CITY OF CONWAY, ARKANSAS HISTORIC DISTRICT COMMISSION

New Accessory Structure & Exterior Modifications

2009 Prince Street - Old Conway Design Overlay District

1 CARPORT NORTH ELEVATION
1/8" = 1'-0"

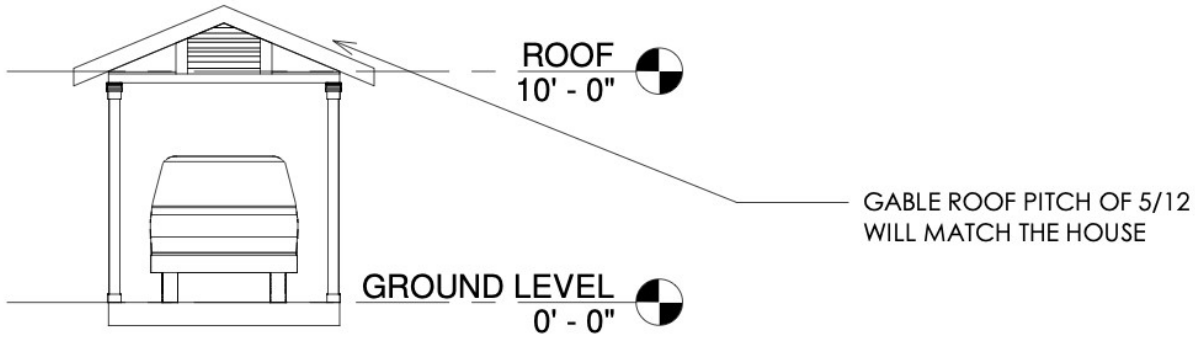
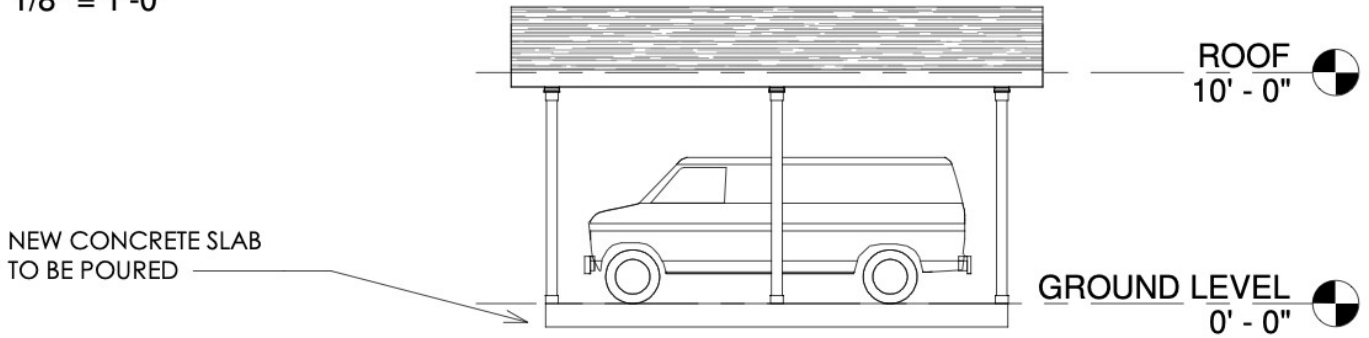
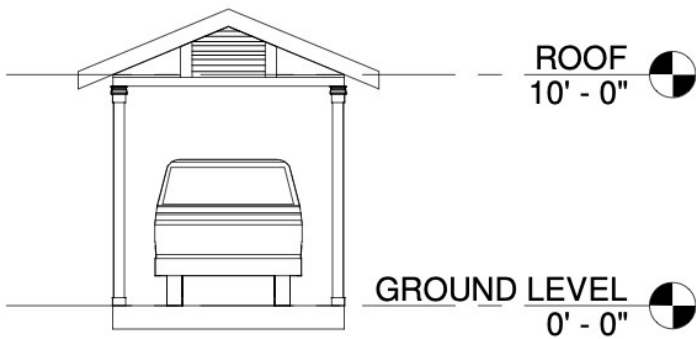
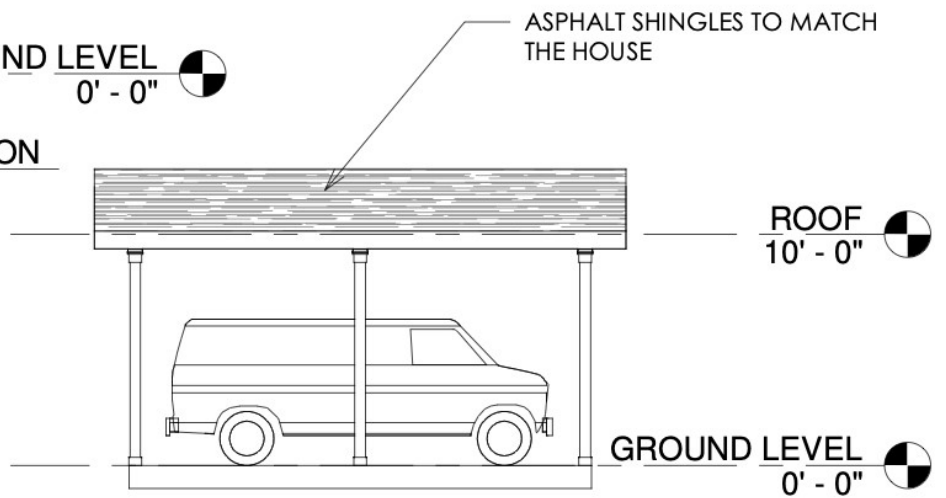
Garages/Outbuildings. Garages should be placed at the rear of the lot. When lot depth prevents a rear placement, the garage may be placed at the side of the structure along the back half of the structure. Two and three car garages should be placed at the rear of the lot in a detached structure.
The proposed carport is placed at the rear of the structure in an appropriate manner.

1 NORTH ELEVATION
1/8" = 1'-0"

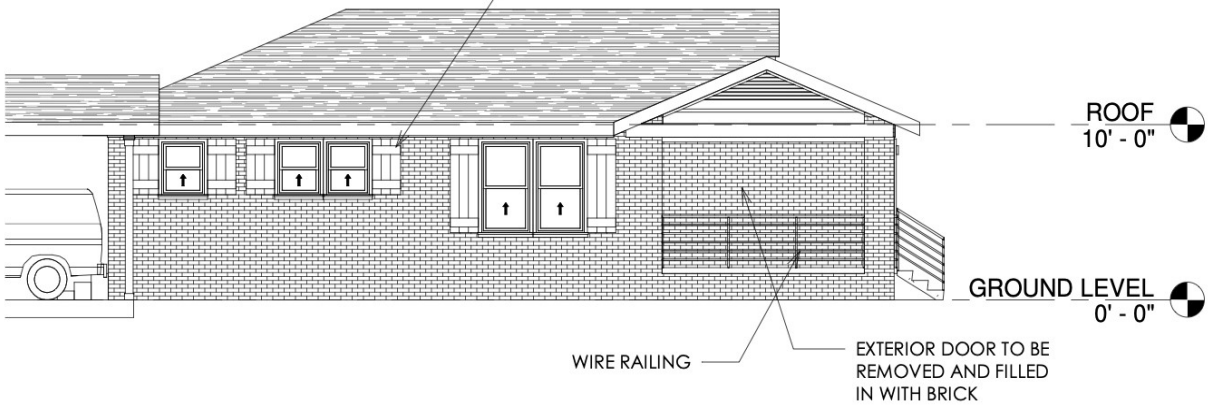
Orientation. The front door of the structure should follow the orientation of entries along the street.
The front door faces the street in a similar fashion to other structures on the street. The structure appears to have previously been used as a duplex and also has a side facing front door that will be bricked in.

The applicant is proposing a non-traditional railing for the porch and stairs. While a modern touch that is a conjectural element to the structure, the regulations do not prohibit this. The enclosure of the side facing door will create a blank void along the façade wall of the porch. Recommend requiring a new window in place of the existing door to fill this void. All new windows and any replaced windows must feature true divided lights windows. Vinyl windows must be 1 over 1 windows.

Roof materials are appropriate and will match the existing house. The proposed shutters do not match the house's style and will not fit the width of windows throughout the house. Recommend not allowing placement of the shutters.

1. Construction be carried out in a manner consistent with proposed plans with exception of conditions 2- 7.
2. Planting of two canopy trees in the front yard is required.
3. The side-facing front entrance shall be partially enclosed and replaced with a window.
4. Require true 1 over 1 windows for all windows added or replaced and all windows on the rear addition.
5. Require fascia and soffits to be finished with wood or wood equivalent construction such as Hardieboard.
6. Shutters shall not be added to the structure.
7. HVAC equipment be placed in a manner to minimize its visibility from the street.
8. Painting of the brick is **VERY** strongly discouraged.
